## San Mateo County Board of Supervisor's Meeting

File Numbers: **PLN 2006-00365**

**SUBJECT:** Summary of Comments, Questions, and Suggestions from a pre-application Public Workshop for a Subdivision, Design Review, Grading Permit and environmental review for a 158 unit multi-family residential development, a day care center, and associated recreation and common areas at 7880 El Camino Real in unincorporated Colma

re: **Response to Planning Department  
El Camino Village, 7880 El Camino Real**

## Podium Level / Site Plan, El Camino Transit Village

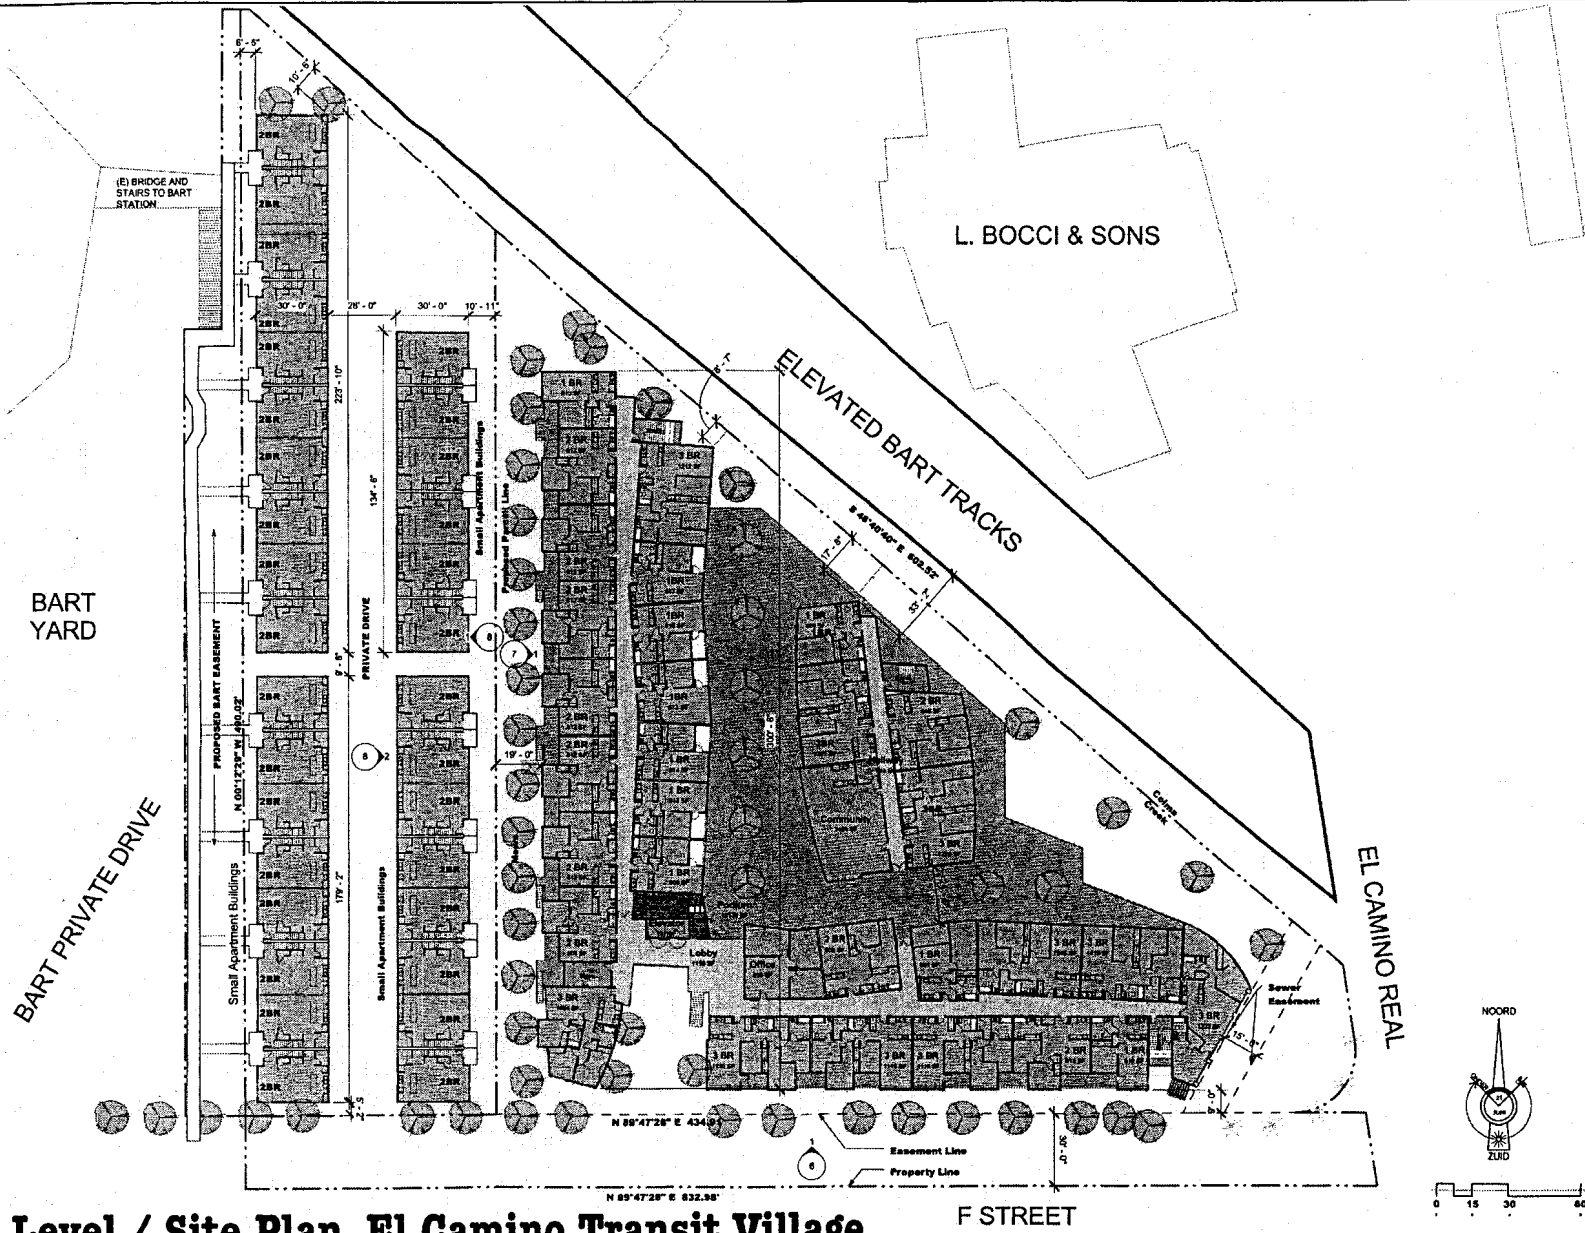
- 4. Public Works: There is insufficient ADA parking provided in both parking schedules on sheet A1.2. A complete review will be conducted when plans are more fully developed.

## F Street Elevation, El Camino Transit Village

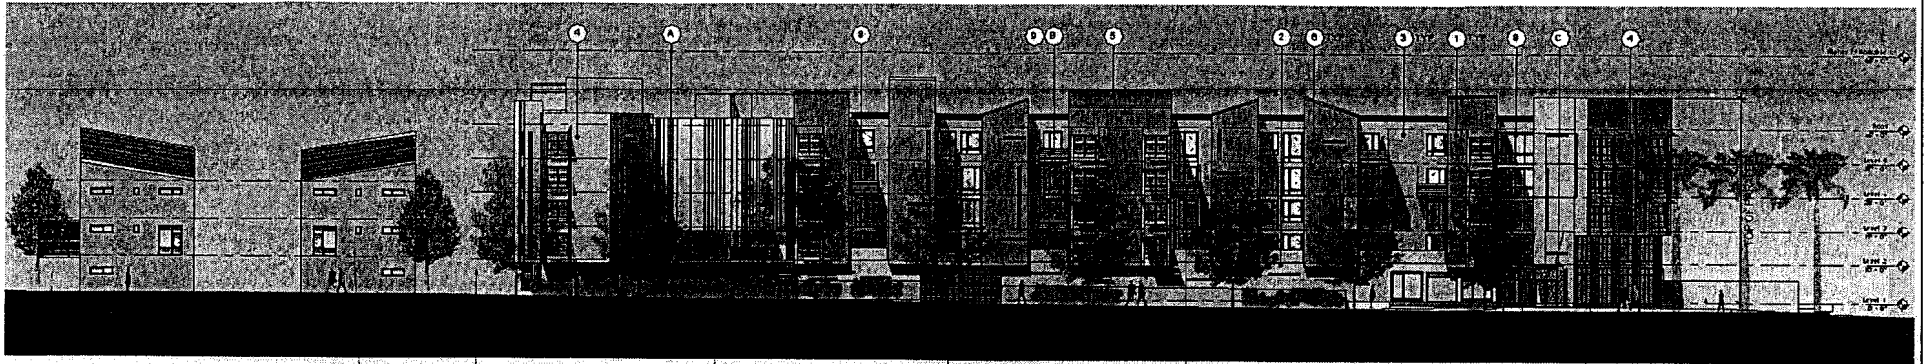
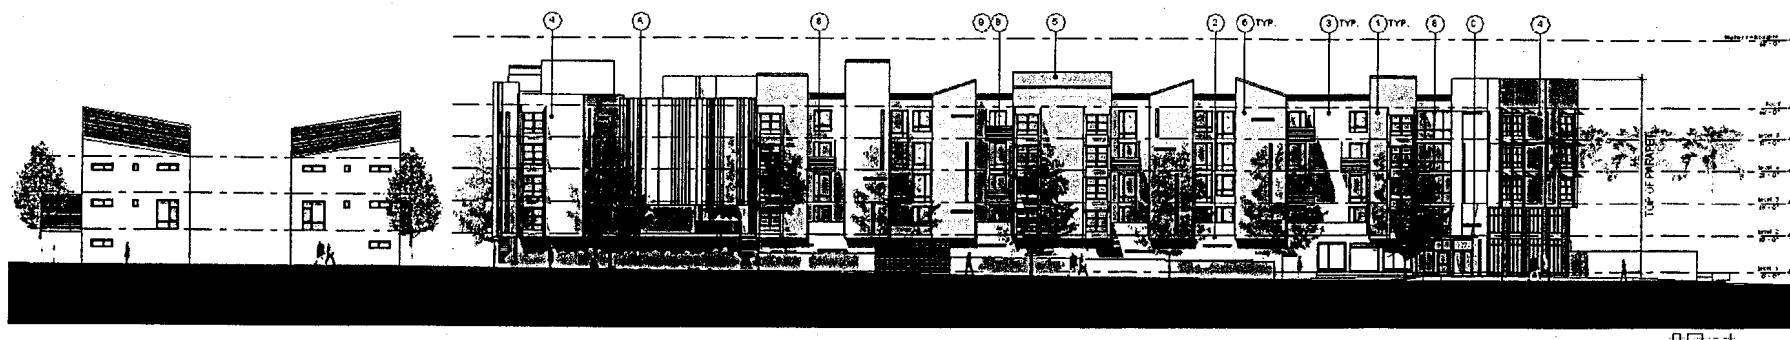
**C. Section 6565.19.C.2.b: Requires variations in floor level, facades, roof patterns, architectural details, and finishes of large buildings to create the appearance of several smaller buildings. Please show how the project meets these requirements.**

Please refer to the project elevations and renderings. There are bays, an inset entrance, balconies, differing end conditions, and a pitched roof with bays that break the cornice line on the long façade at F Street that vary its appearance. We believe the design complies with the intent of this section of the planning code.

C2.0

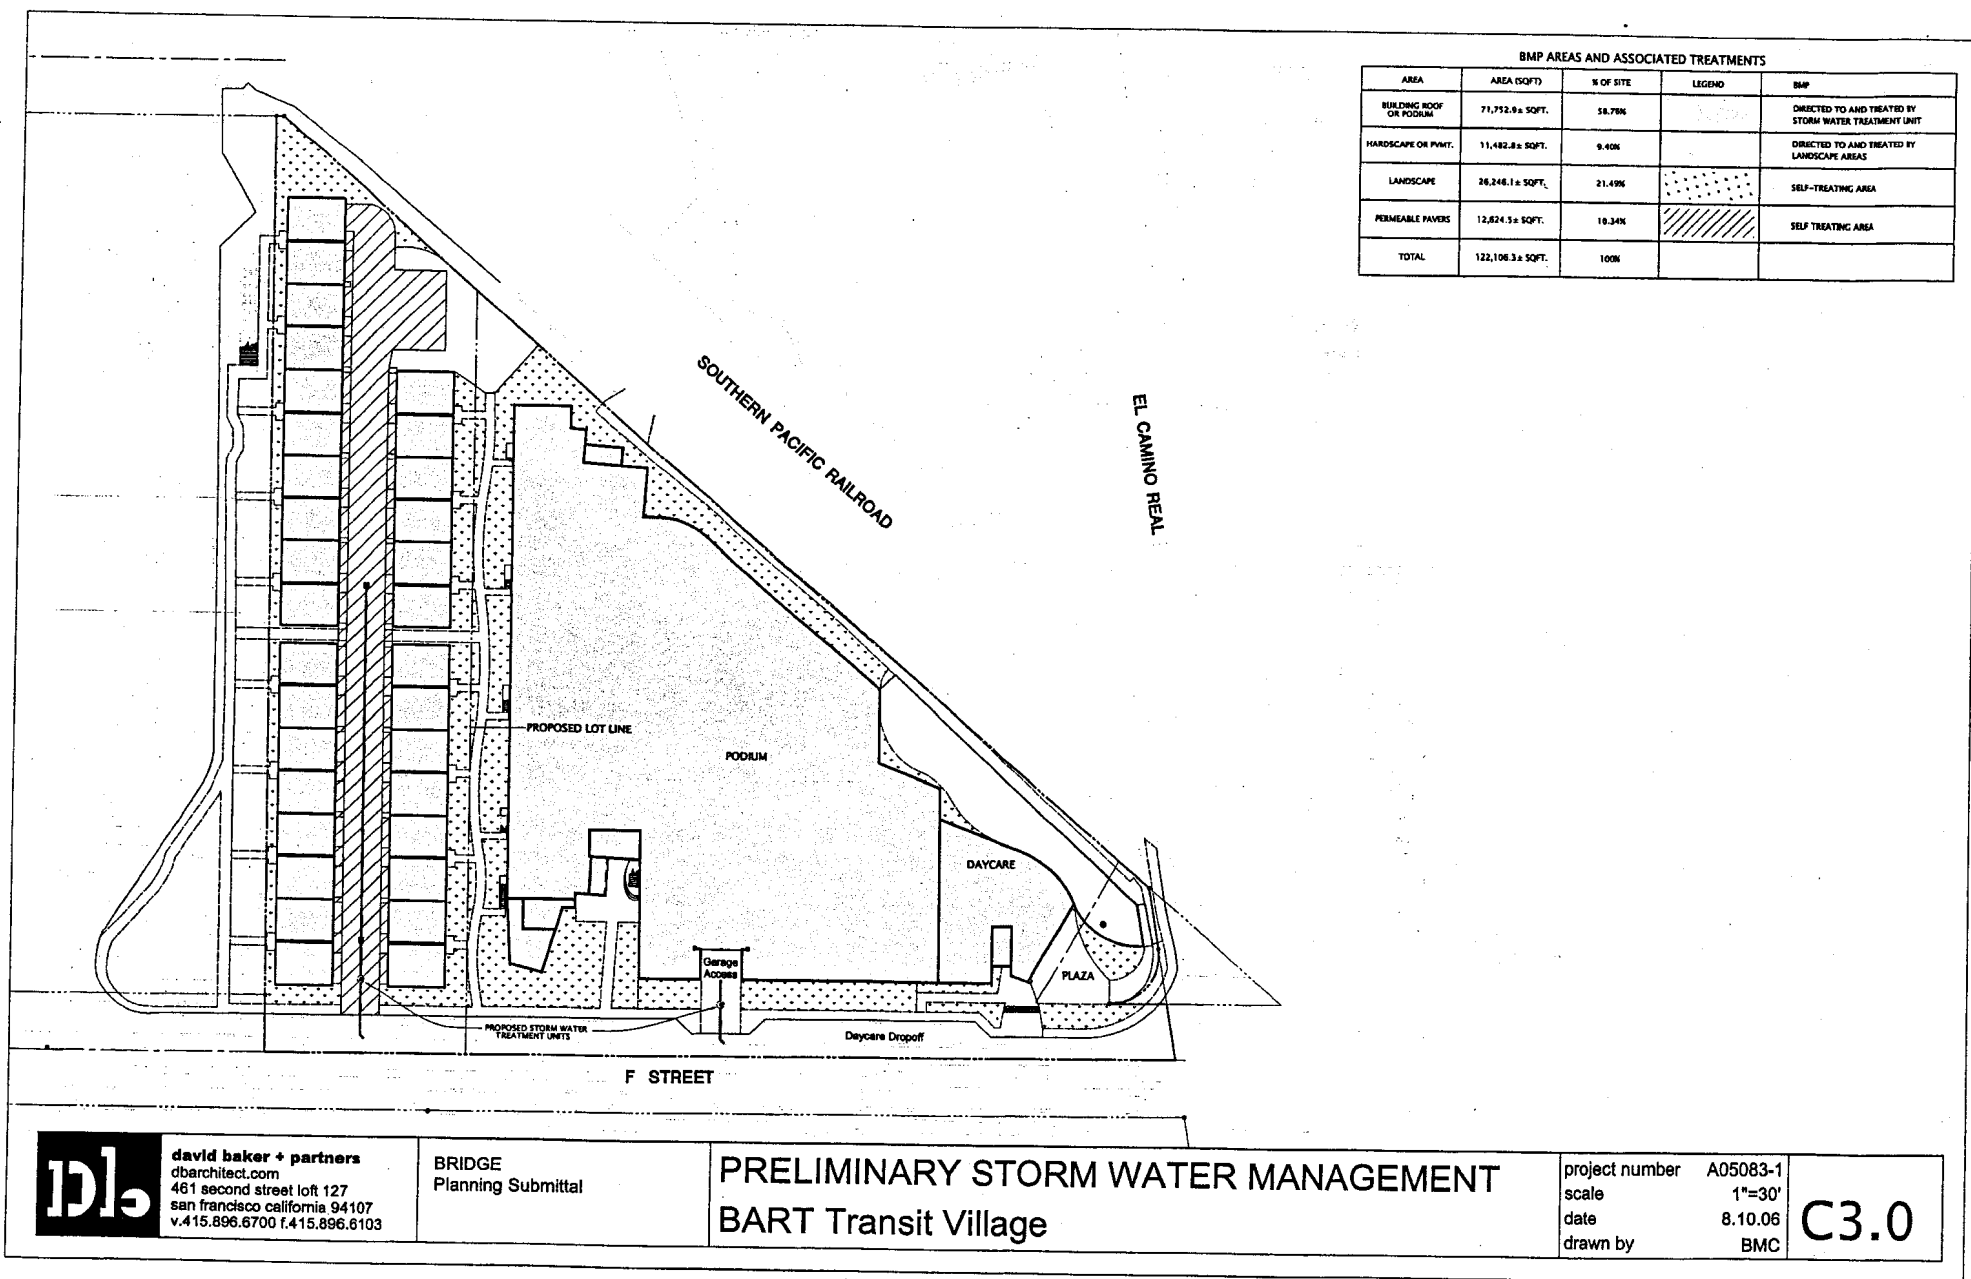
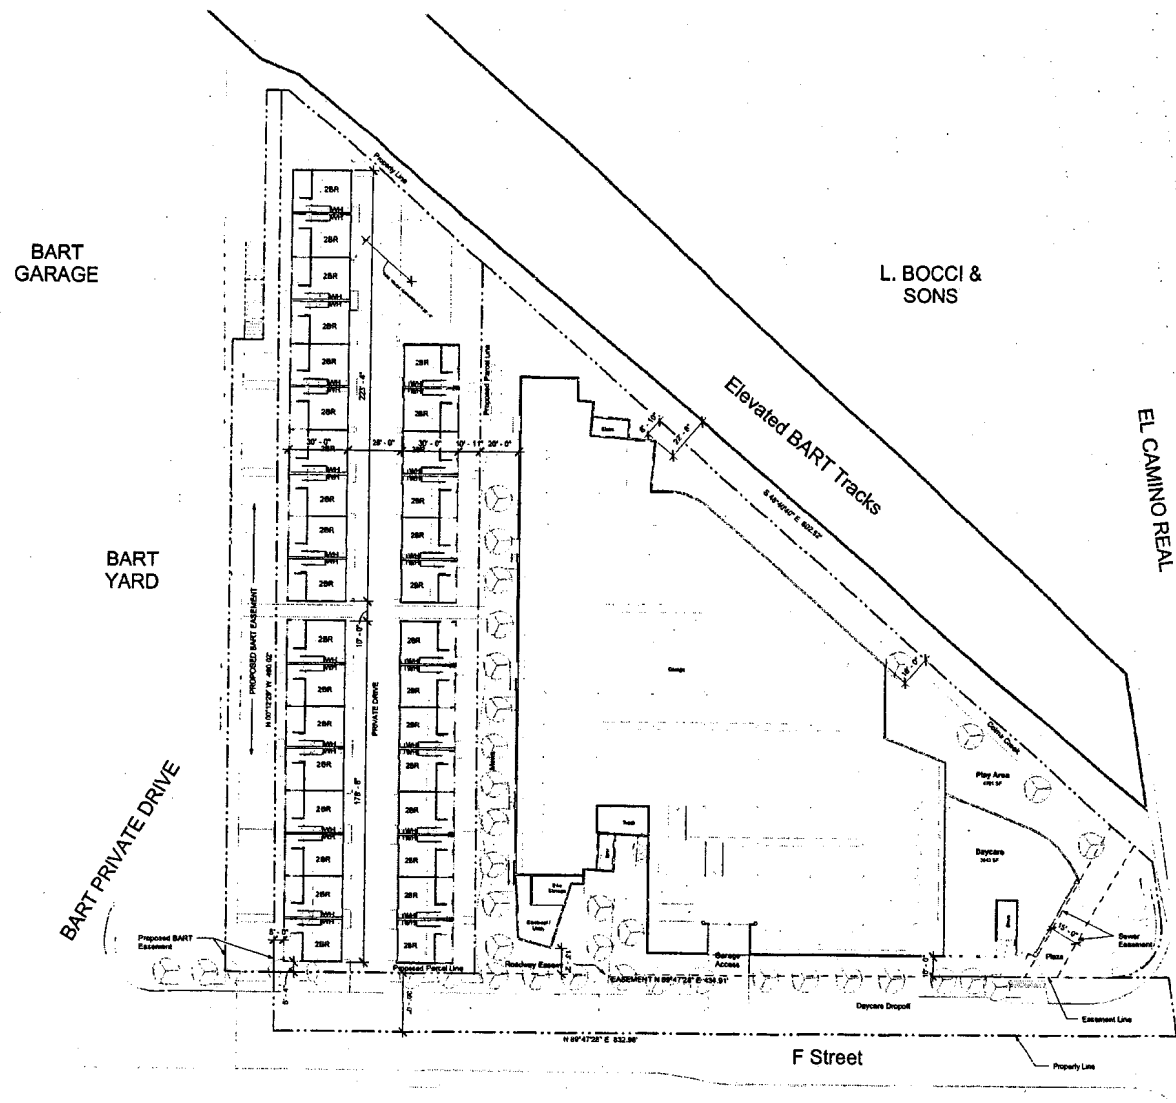
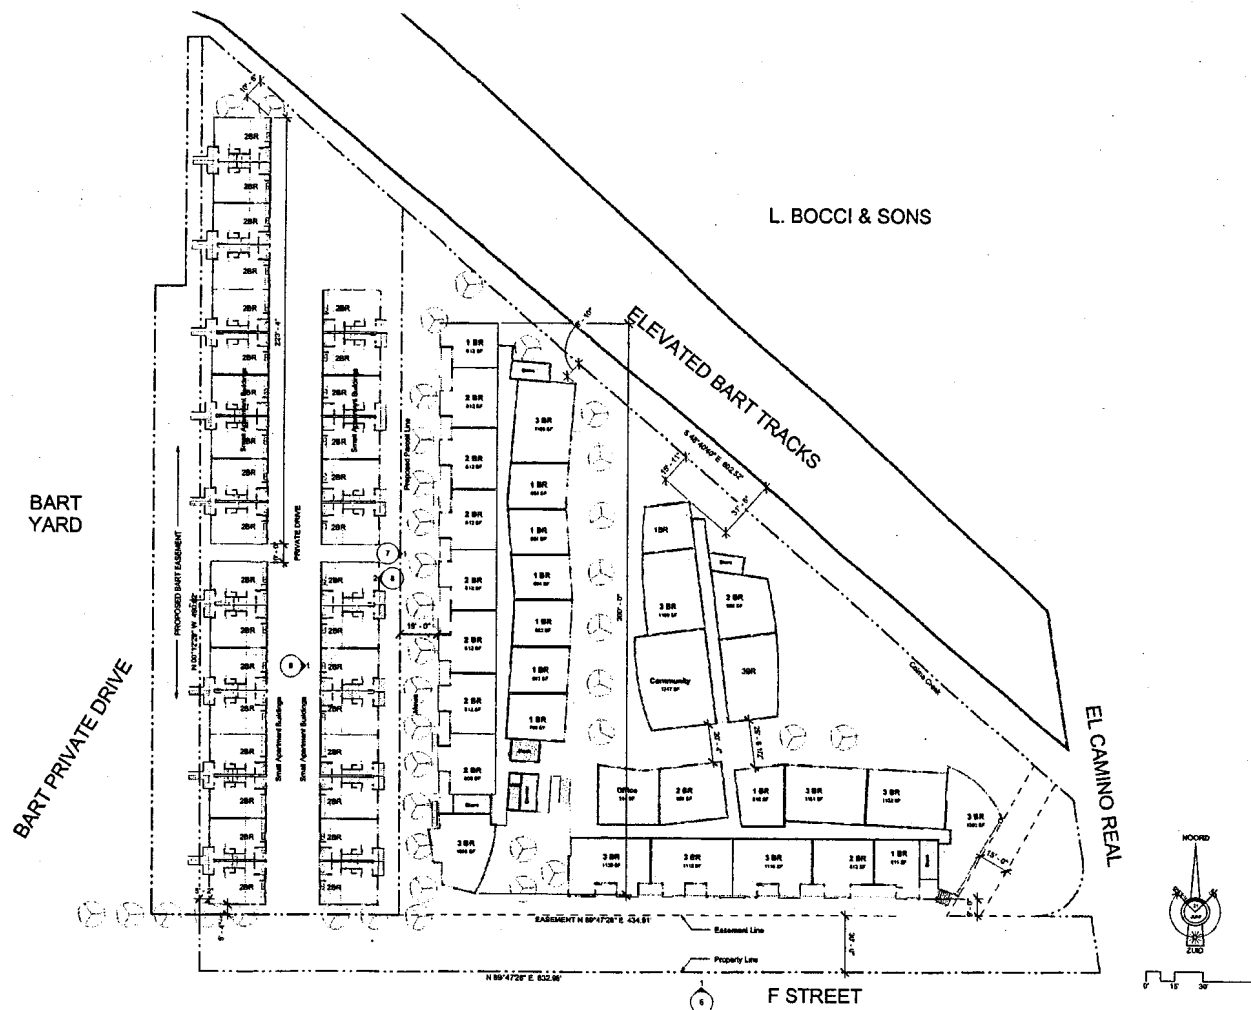
1. The Project plans (Sheet C2.0) show encroachment of the sidewalk/walkway and parking onto the (shown) 30' easement for roadway and utility purposes on F St. It appears that the proposal is to eliminate/reduce the traffic lanes from the existing two (2) lanes to one (1) lane. There are two (2) left turn lanes from El Camino real onto F Street traveling NW. Please justify and comment.
2. The plans also show daycare drop-off very close to the El Camino Real and F Street intersection. Vehicles maneuvering in and out of this drop-off too close to the intersection might cause traffic problems. Please comment.
3. Provide a striping plan showing the proposed traffic patterns on F Street.
